ADDENDUM NO. 1
DATED MAY 13, 2016

CONTRACT DOCUMENTS
FOR
ITB# 4446 - LESLIE PARK GOLF
COURSE GOLF CART STORAGE
BUILDING FOR THE
CITY OF ANN ARBOR

ELECTRICAL PLAN

SHEET No. **E-101**

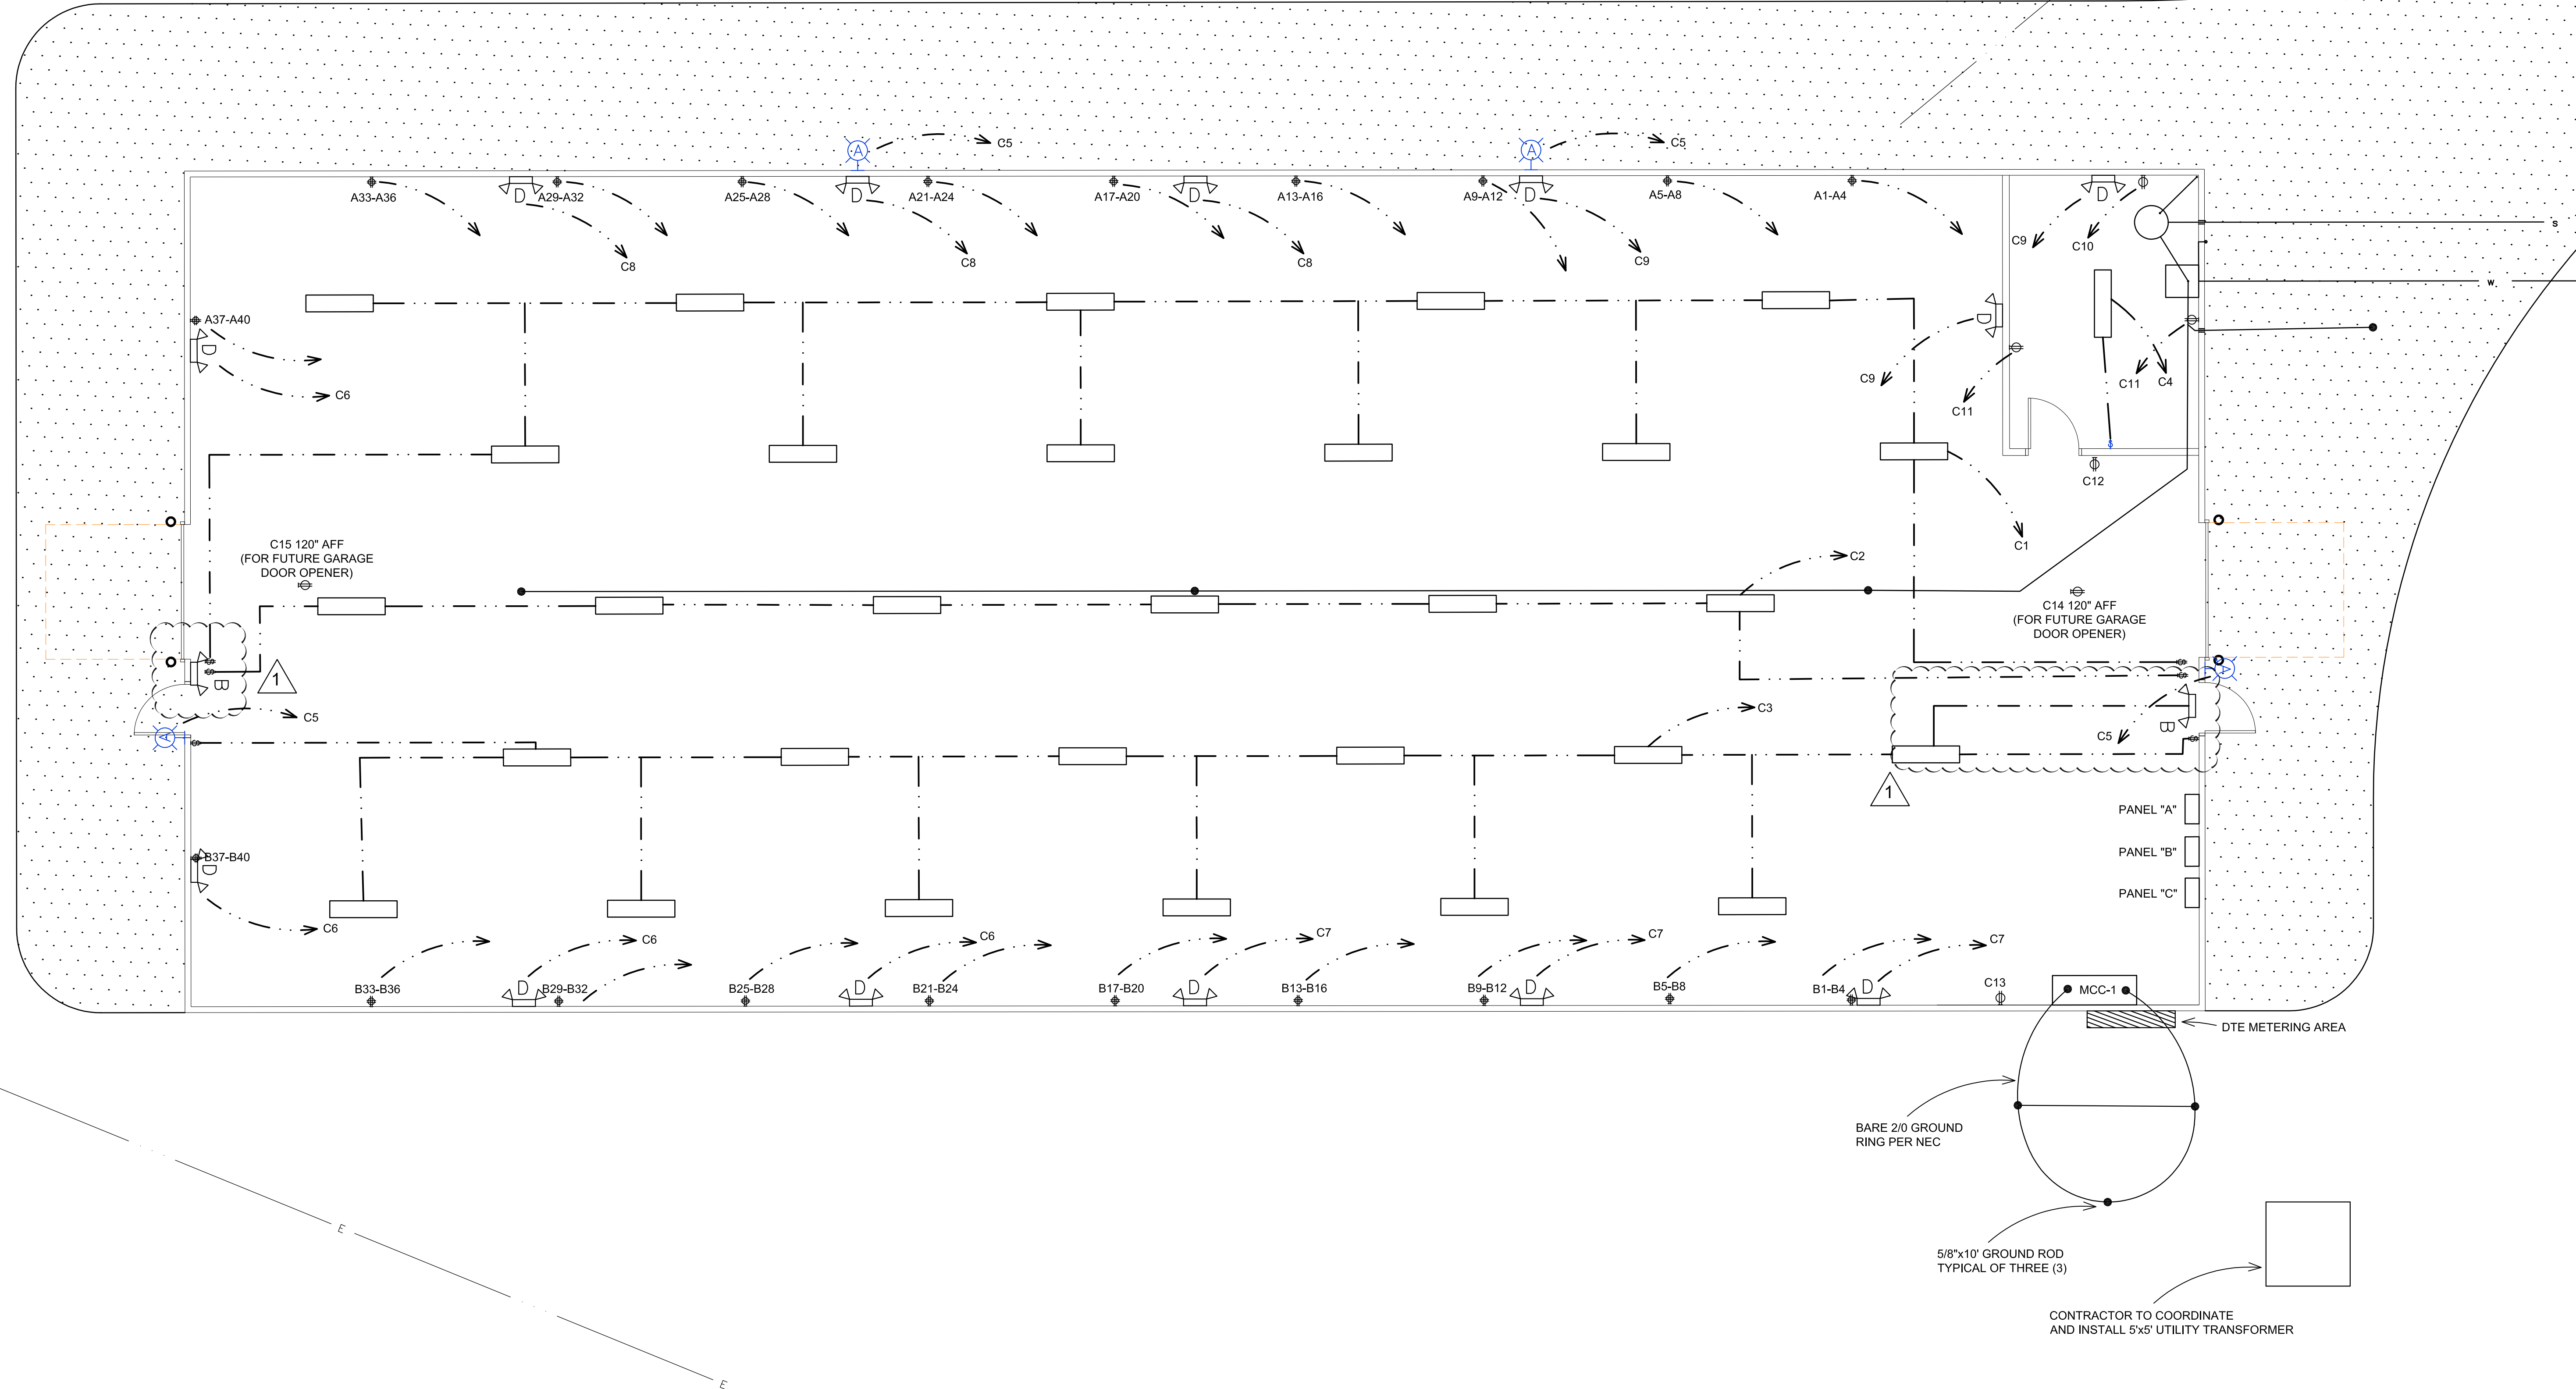
Q2. The plans show DECO transformer in different locations. Please confirm location.

Q4. Will the CT cabinet and DECO meter be located on the southeast corner of the building?

Q8. Plans do not call for any Type "B" Exit/Emergency combos. Are there any exit lights required for the building?

A. Sheet 15/16 shows the general location of transformer. This is up to the Contractor to coordinate final location with DTE Energy with no cost impact to the Owner.

A. Yes, please refer to Sheet 15/16. It is also acceptable to mount directly onto the transformer.

A. See updated Drawing E-101-AA. Yes.
